Product Improvement: Ball Float Steam Trap G20N

Ball Float Steam Trap G20
Product improvement and model name change

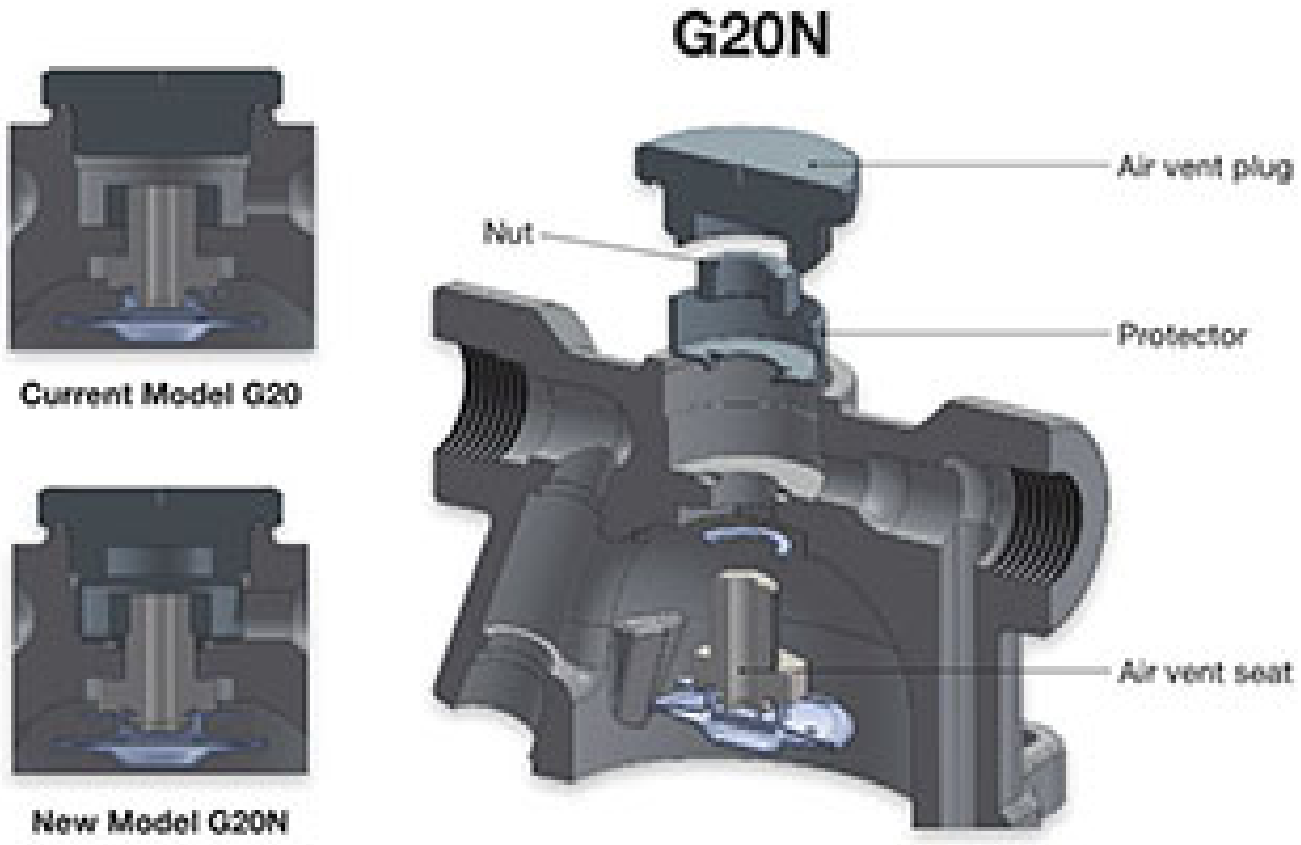
MIYAWAKI would like to announce the following improvements made to the model G20:
1. Addition of a stainless steel protector to the air vent
2. Change of the design of the air vent plug
3. Change of the size of the air vent nut (19 mm k 17 mm)
4. Increase of the length of the air vent seat (+ 2mm)

Due to the improvement the model name will be changed to G20N.
The technical specification of the product has not been changed.
